Webster University
Interdisciplinary Science
Building

**LEVEL 01 FOUNDATION
PLAN AND LEVEL 02
FLOOR FRAMING PLAN**

SUBMITTAL IDENTIFICATION SHEET

RE: Sawcut Plan

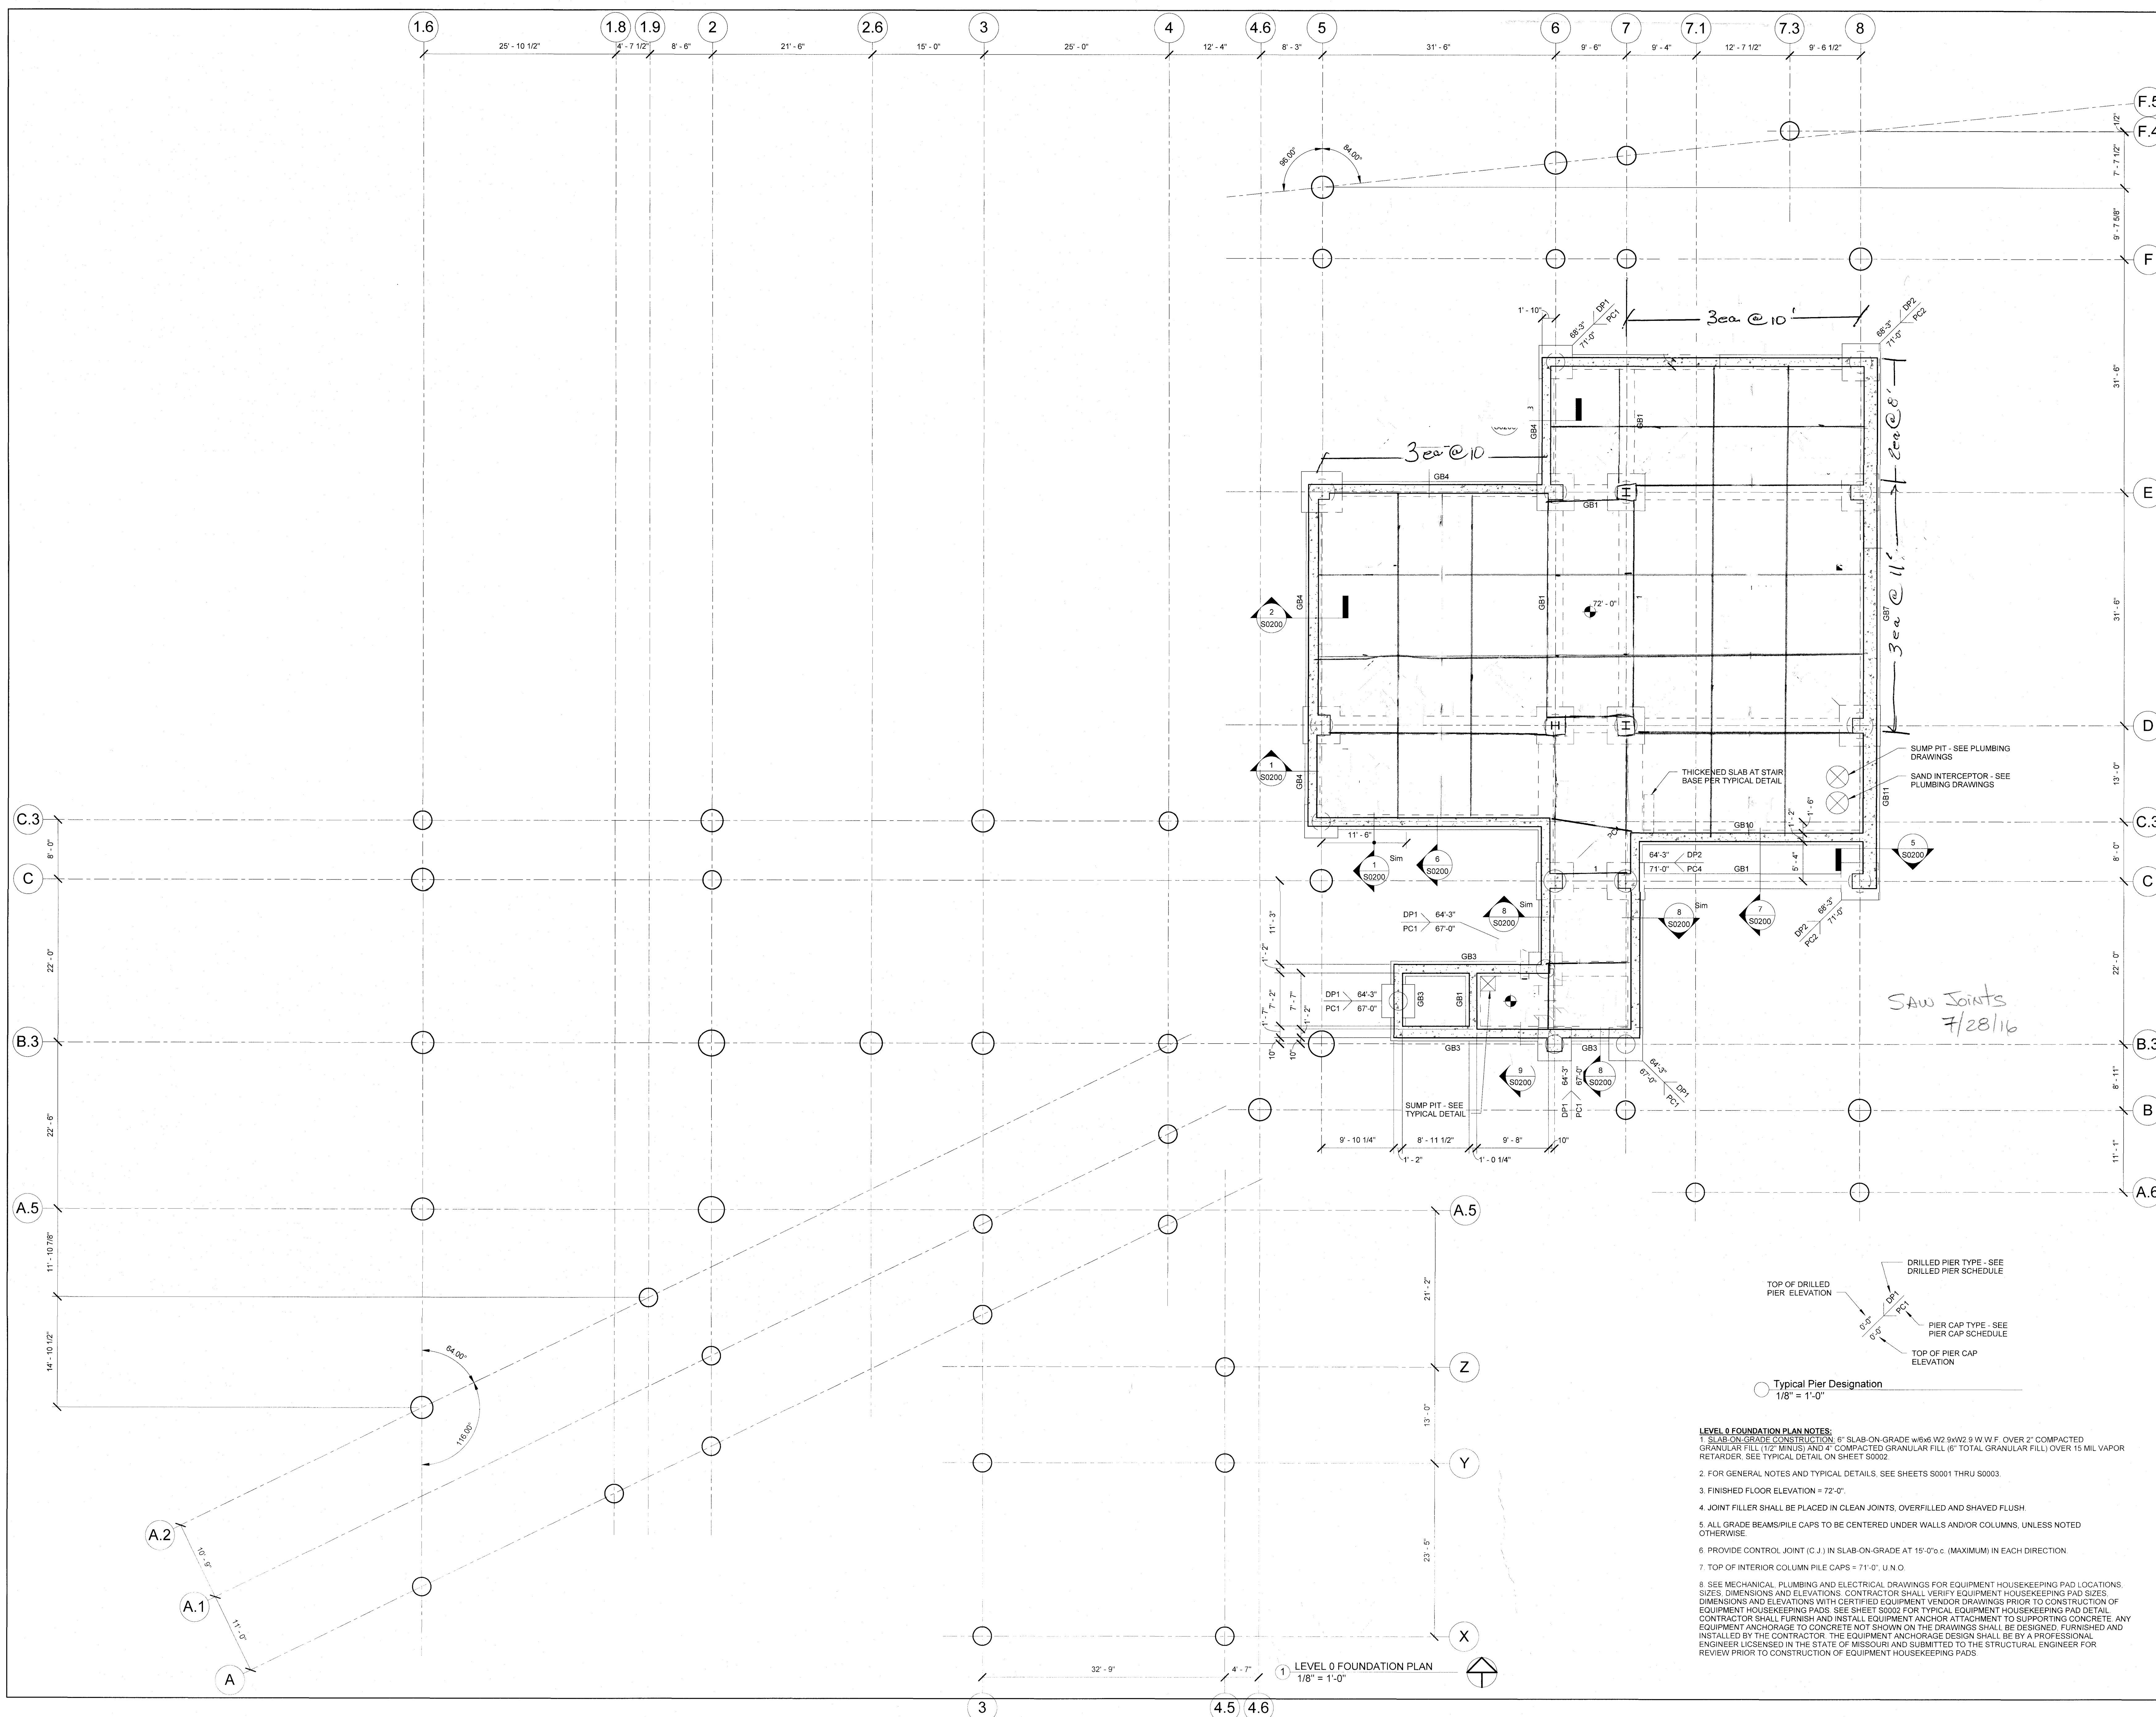
CONTROL JOINT LAYOUT IN
GENERAL IS ACCEPTABLE. CUT
SPACING AND SECTION LENGTH TO
WIDTH RATIOS ARE REASONABLE.
